Midway City Council 6 April 2021 Regular Meeting

Farm Meadows Subdivision / Preliminary and Final Approval

CITY COUNCIL MEETING STAFF REPORT

Farm Meadows Subdivision - Preliminary / Final Approval

A DENSITY REDUCTION SUBDIVISION REVISED FINAL APPLICATION

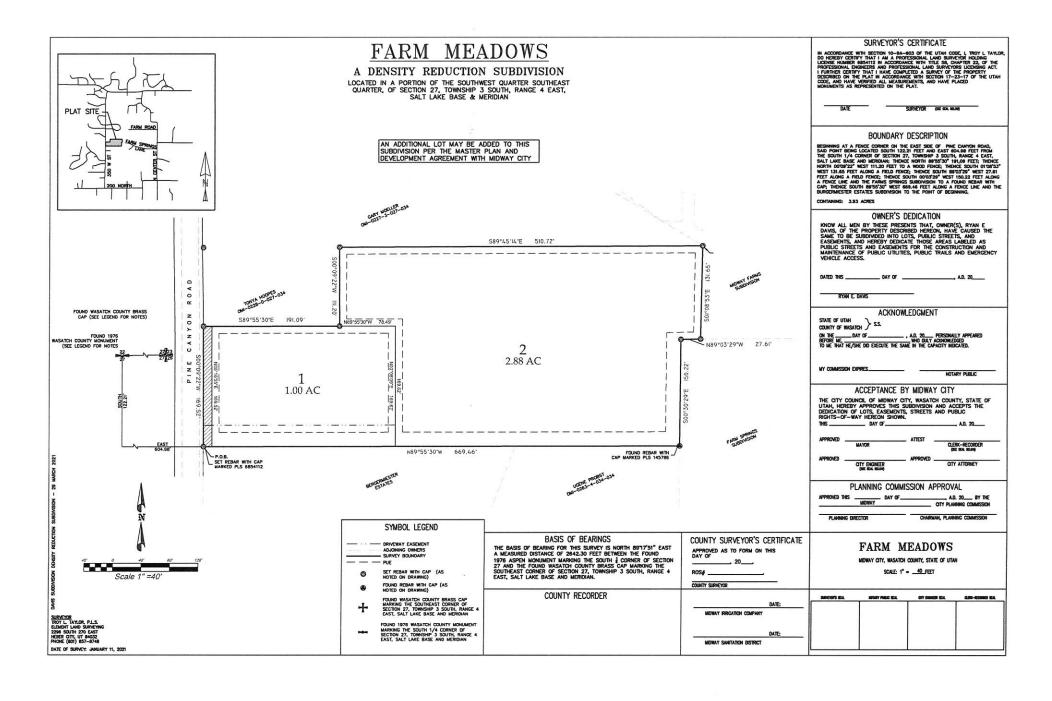
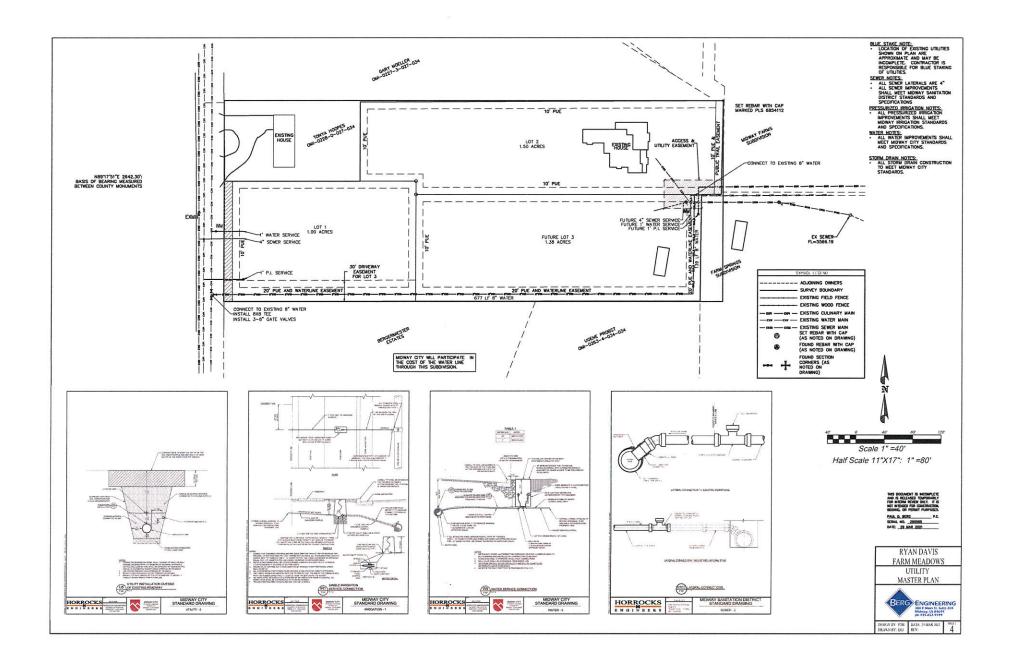
- The proposed development will be served from the Gerber Mahogany Springs pressure zone.
- Lot 1 will connect to the existing water line within Pine Canyon. Lots 2 and 3 will connect to the existing water line within Farm Springs Lane.
- An 8" PVC line will need to be installed from Pine Canyon and tie into the 8" line that was a part of the Farm Springs development. The existing 10" transite line that was abandoned on the Farm Springs development will need to be removed and replaced or abandoned.

- A 30' driveway easement across lot 1 will need to be placed on the plat map for driveway access to lot 3.
- The right of way half width (28') of the Pine Canyon Road should be dedicated to the city along the frontage of the proposed development.

The existing shoulders will accommodate the storm drain for these lots.

• The cost of installing a 5' bike lane should be paid to the general trail fund. This money will be used to install future trails within the City.

Lot 1 will connect to the existing pressurized line within Pine Canyon and lots 2 and 3 will connect off of Farm Springs Lane.

REVISION NOTE: THIS PLAN SET HAS BEEN REVISED TO ADDRESS MIDWAY CITY COUNCIL COMMENTS FROM MARCH 2, 2021
